**Project Name: SCF Valley Native Primary Care Center Roof Replacement**  
**Project Number: 231097**

**20 December 2024**

**Addendum Number 1 Language**

**2 EF1-9 CURB DETAIL**  
A503 1 1/2" = 1'-0"  
0' 6" 1' 2'

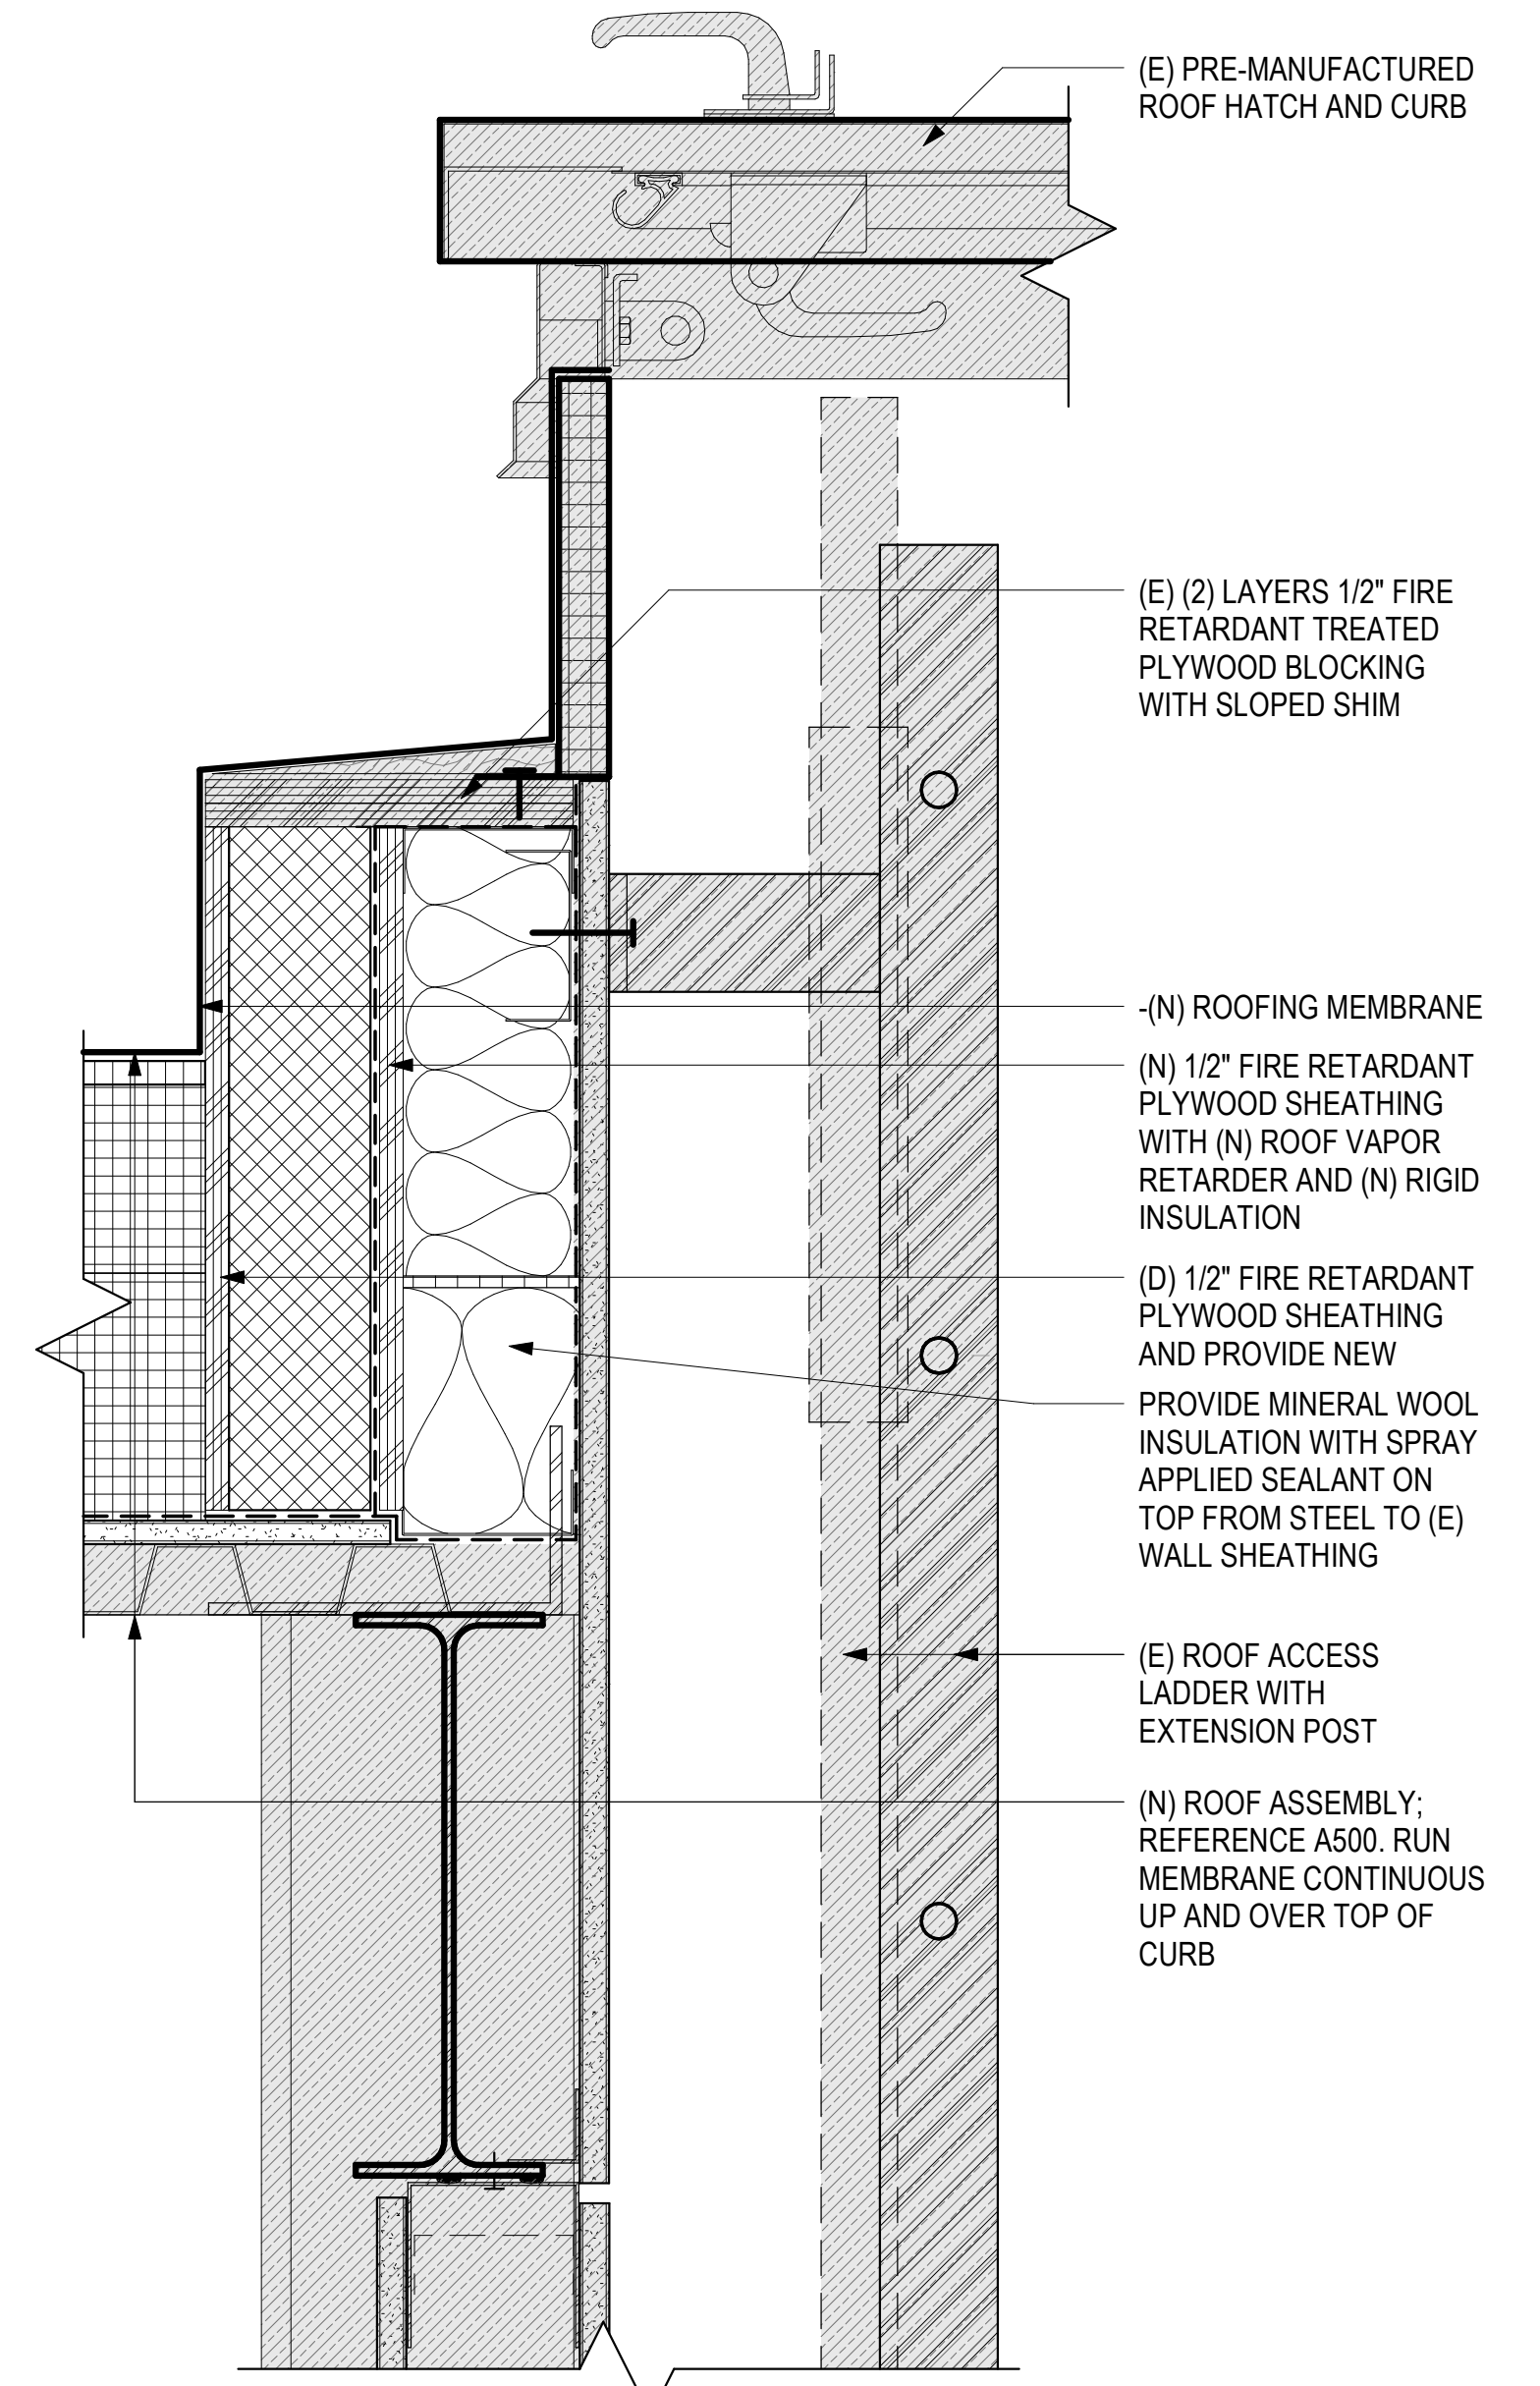
2. Sheet A131, Detail 1 - New Upper Roof Plan -Northwest Sector, change the location of the roof curb for future EF1-9 as indicated on the attached Sheet A131.
3. Sheet A134, Detail 1 - New Upper Roof Plan -Southeast Sector, change the location and orientation of the steel for the future MRI chiller and the piping enclosure as indicated on the attached Sheet A134.
4. Sheet A503 – Roof Details, add detail 2/A503 – EF1-9 Curb Detail as shown on the attached Sheet A503.

9 TRAVEL RESTRAINT ANCHOR  
1 1/2" = 1'-0"

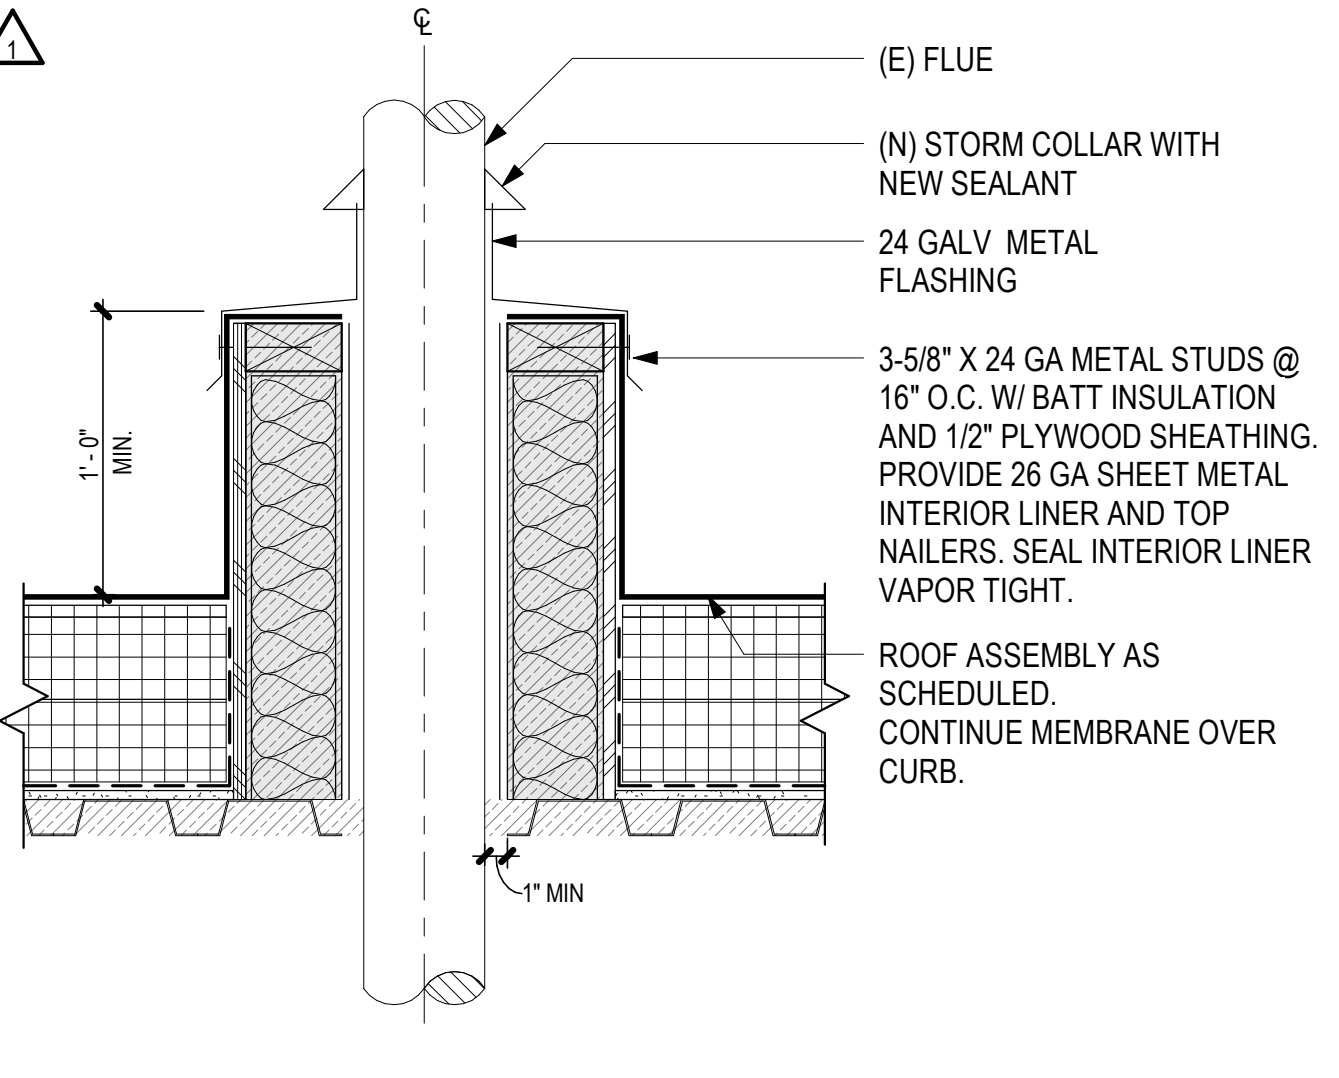
5. Sheet A505, Detail 9 – Fall Protection Detail, change the detail and rename the detail as indicated shown on the attached Sheet A505.
6. Sheet A600 – Penetration Schedule, add EF1-9 curb as shown on the attached Sheet A600.
7. Sheet S001 – Wind Uplift Map, add attached Sheet S001.
8. Sheet S002 – Roof Framing Plans, add attached Sheet S002.
9. Sheet S003 – Structural Details, add attached Sheet S003.
